# DESIGN DRAWINGS

*Oregon Square*

*Updated: September 14, 2015*

# COMMENTS TO ADDRESS - POST DR I

MODIFICATION #2

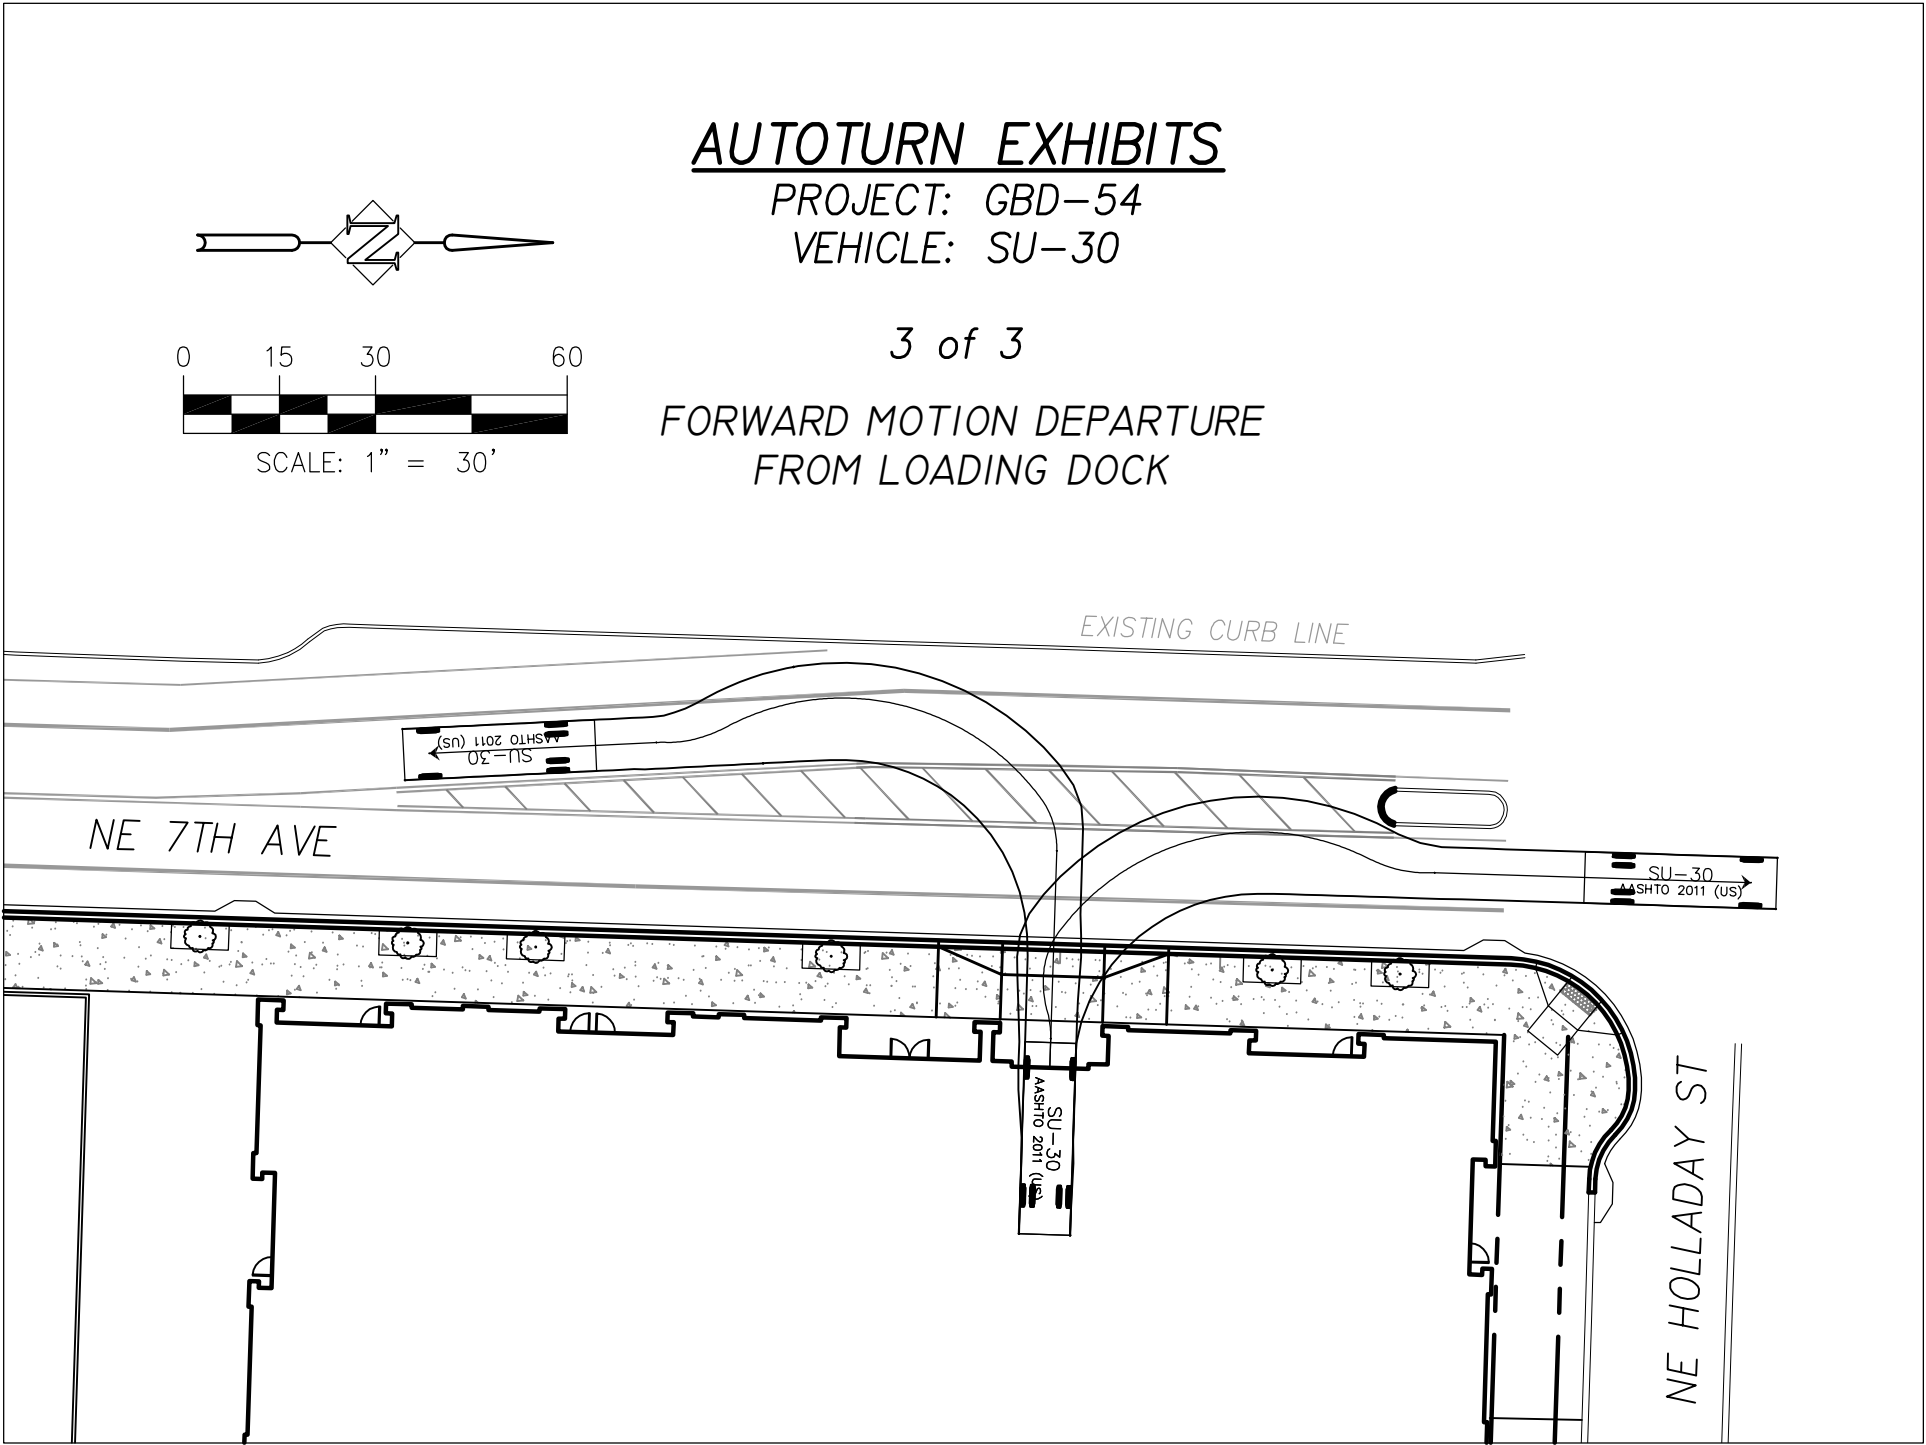
33.266.310.F.2.

General Standard: Forward motion loading: In the Central City plan district, loading facilities that abut a light rail or streetcar alignment must be designed so that vehicles enter and exit the site in a forward motion.

The Block 91 proposed loading facility meets the proscribed minimum dimensions of 10’w x 35d’ x 13’h and is accessed off of NE 7th Ave, which abuts the streetcar line running in the north-south direction. The streetcar rails occupy the southbound lane (the west side of the street), which is currently separated from the northbound lane by a concrete median. Block 91 only has two street frontages, NE Holladay and NE 7th Ave. NE Holladay is fortified by the Max station and is a dedicated “Green Street”, making it inappropriate for service functions. Block 91 fronts the central pedestrian plaza to the east and south; this plaza only sees vehicular traffic during emergencies or during special events; it is not available for daily or regular service activities. For this reason a drive-through loading bay, allowing forward motion when entering and leaving, is infeasible. The NE 7th Ave frontage is the only remaining frontage available for loading, and this can only be accomplished by reverse-motion access and forward motion exiting.

Access to the loading space is proposed to be accomplished by allowing trucks to back in to the loading space from the northbound lane. The attached loading diagrams showing the maneuvering clearances for an SU-30 truck demonstrate that the turn radius and maneuvering clearances required for forward motion access (illustration 1 of 3) are more disruptive to southbound traffic and the streetcar rail alignment than reverse motion loading, and will require removal of the existing median. Forward motion loading requires a northbound truck to swing wide into the southbound lane to access the loading dock, while reverse-motion loading (illustration 2 of 3) from the northbound lane requires a 2 point turn within the northbound lane, with no disruption to the southbound traffic or streetcar. Illustration 3 of 3 shows that forward motion exiting from the loading dock into either the northbound or southbound lanes is not disruptive to traffic flowing in the opposite direction. We request that a modification be granted to allow reverse-motion access to the loading dock on NE 7th Ave.

# MODIFICATION #3

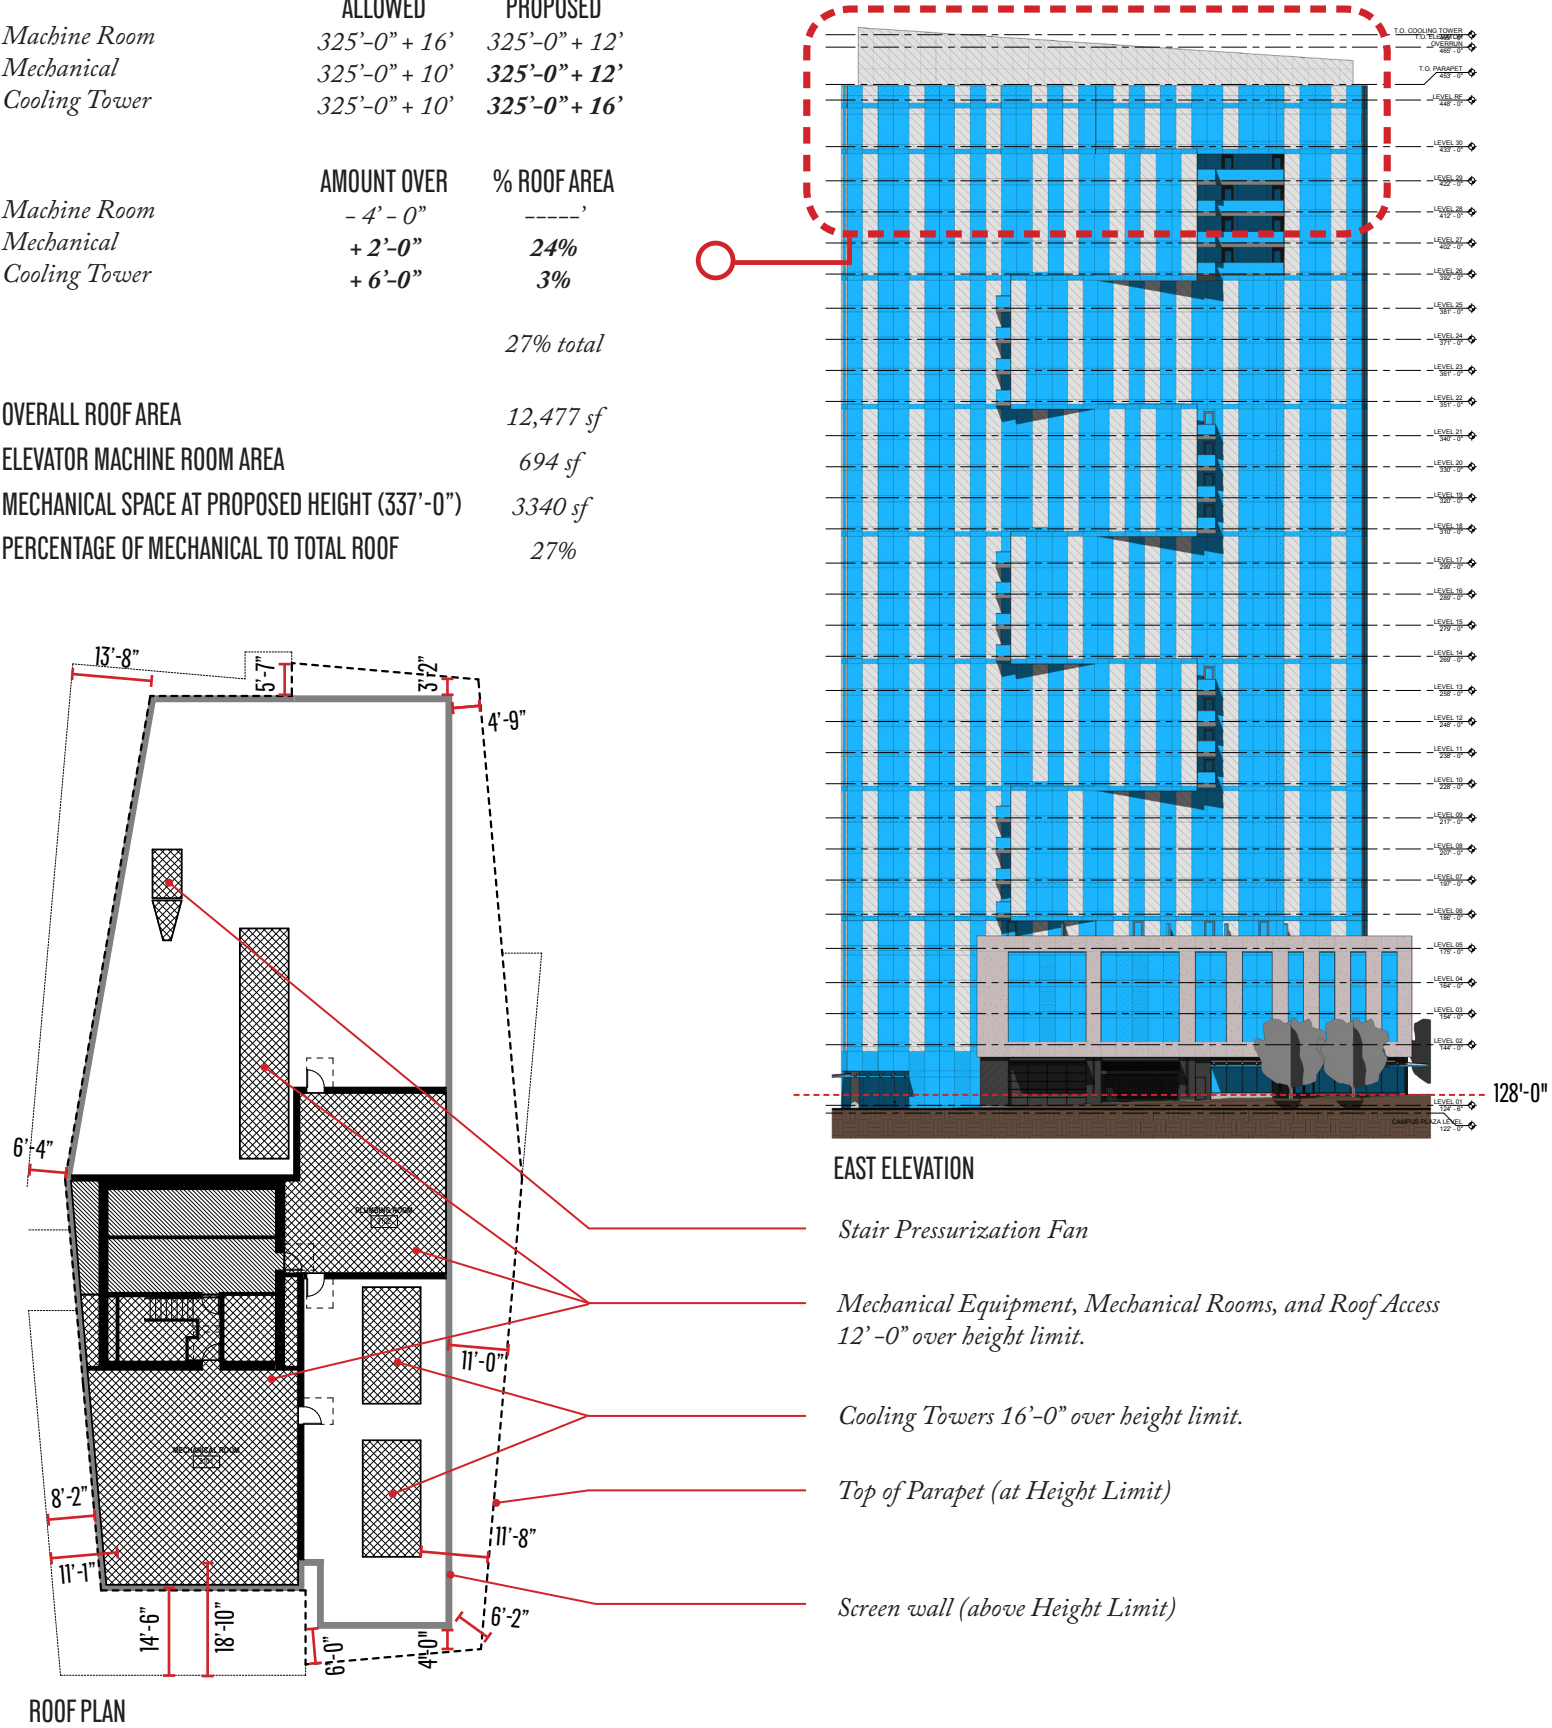
33.130.210 .B.2.  
General Standard: Roof top elevator mechanical equipment may extend up to 16 feet above the height limit, and other roof top mechanical equipment or roof access stairwells must be set back at least 15 feet from roof edges that parallel street lot lines. Mechanical and roof access equipment that occupies up to 10% of the roof area may extend up to 10' above the height limit.

**PROPOSAL:**  
Block 103 has a maximum allowed height of 325' based on the allowable 250' height in this zone, plus 75' of bonus height due to residential use. Currently the parapet is located at elevation 453'-0" (325'-0"), and the back of walk elevation at the highest building corner (the corner of NE 9th ave and vacated NE Pacific) is 128', putting the building parapet at 325'-0", the maximum height.

The roof mechanical equipment and mechanical rooms are currently 11'-8" minimum from the roof edge on the east side (NE 9th Ave frontage), and 2,888 sf (23% of the overall roof area) of the rooftop mechanical equipment/mechanical rooms exceed the 325' height. These rooms are 12'-0" above the limit at access rooms and mechanical rooms, and the cooling towers (394 sf of the 2,888 sf) are 16'-0" above the height limit. The percentage of equipment in excess of the height limit compared to the overall roof area is higher than the required 10% because the tower narrows and terraces back as it approaches the roof, leaving a smaller roof footprint, and thus denser mechanical equipment set closer to the roof edge. Instead of enlarging the overall roof plate to increase the distance from the roof edge to the equipment and to decrease the percentage of the roof equipment relative to the overall roof area, we propose adding a screen around the roof, set back as close as 4'-0" from the roof edge at the south elevation, and 3'-2" at the north elevation, to screen the equipment to appear an extension of the building below. The screen starts at 8'-0" above the 325' height at its low side, and will extend up to 18'-6" above the height limit at its high side (the south side, NE Oregon Street frontage). While the screen exceeds the height limitations, it enhances the character and architecture of the building, capping the tower with an integrated architectural element that screens both the elevator and mechanical appurtenances that comply with the height restrictions and those that do not comply, mitigating the visual impact of all roof equipment.

ALLOWED	PROPOSED
Machine Room	325'-0" + 16'	325'-0" + 12'
Mechanical	325'-0" + 10'	325'-0" + 12'
Cooling Tower	325'-0" + 10'	325'-0" + 16'
